**RE: APPROVAL WITH MODIFICATIONS WORK PLAN FOR INVESTIGATION OF THE OVERFLOW DITCH AND FAN-OUT AREA OF RAILROAD RACK LAGOON, SWMU #8
GIANT REFINING COMPANY, CINIZA REFINERY
EPA ID #: NMD000333211, HWB-GRCC-06-001**

The New Mexico Environment Department (NMED) has reviewed Giant Refining Company, Ciniza Refinery's (Permittee) *Work Plan for Investigation of Overflow Ditch and Fan-Out Area of Rail Road Rack Lagoon, SWMU #8* (Work Plan), dated August 29, 2006. NMED hereby approves the Work Plan with the following modifications. The Permittee must implement the modifications to the Work Plan described below and document them in the investigation report.

FIGURE 2

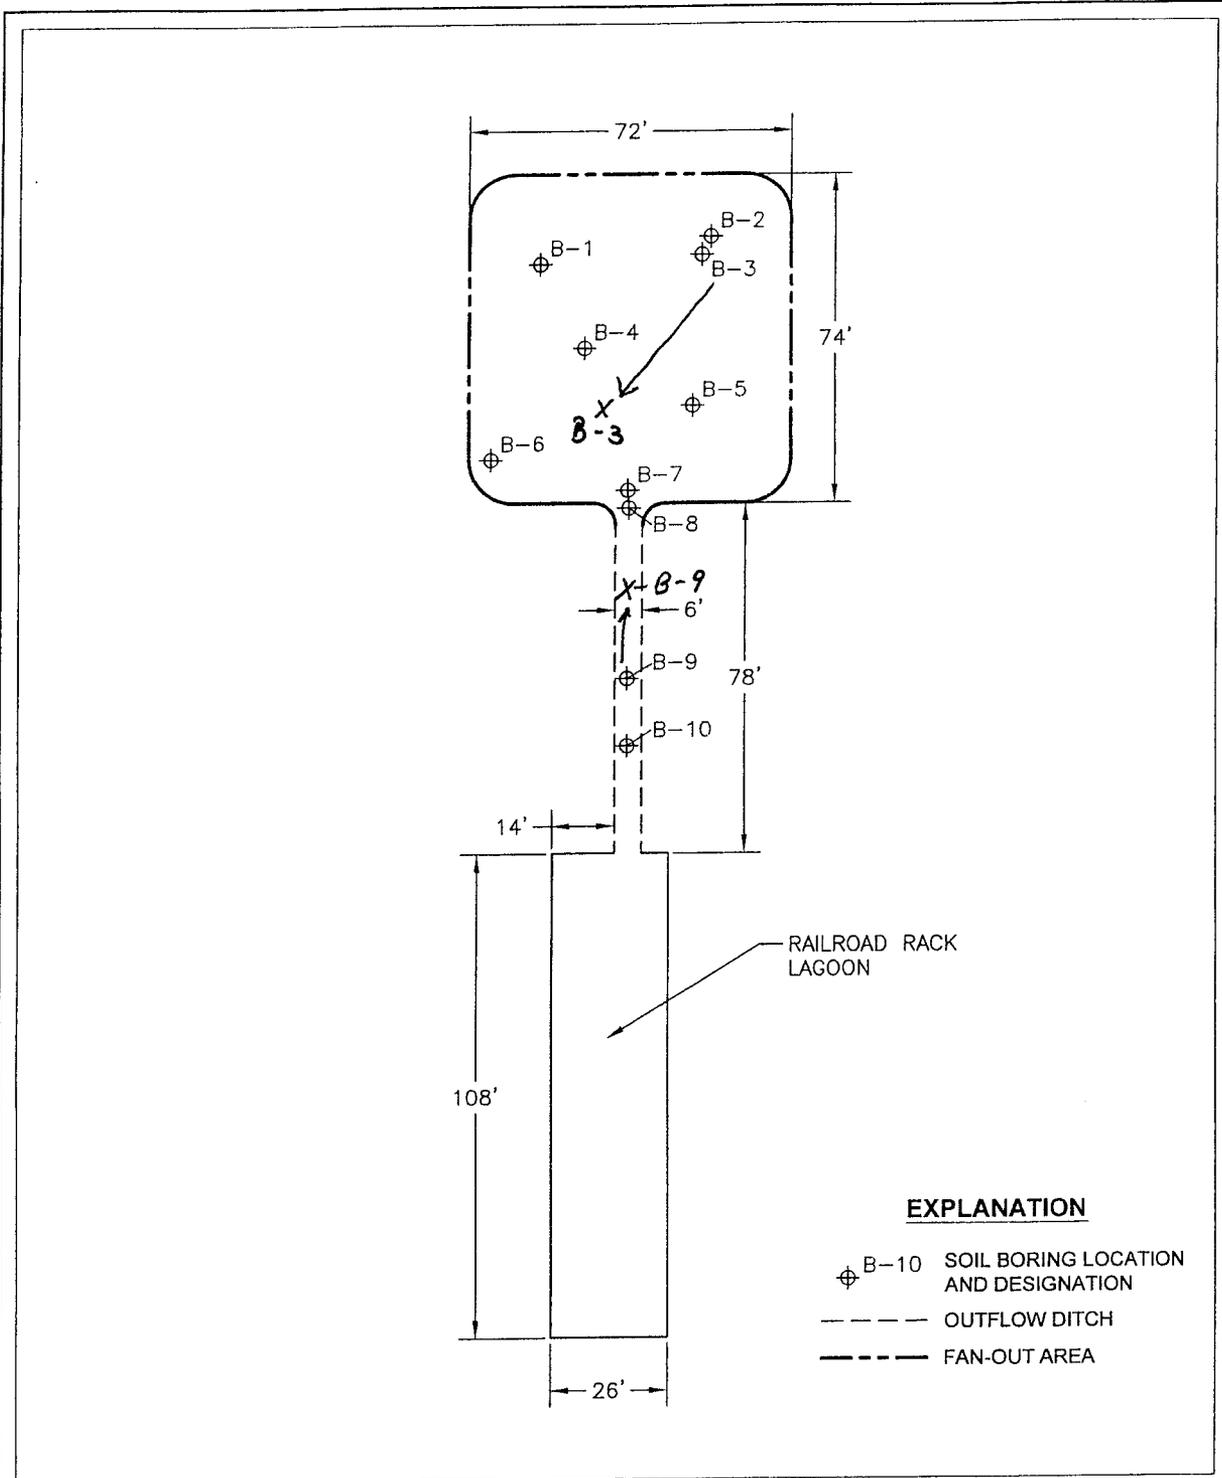
The Permittee must move the locations of soil boring B-3 and B-9 to the locations identified in Attachment 1 of this letter. To provide for more evenly distributed locations, sample point B-9 must be moved further north toward B-8 and sample point B-3 must be moved southwest, between B-4 and B-7.
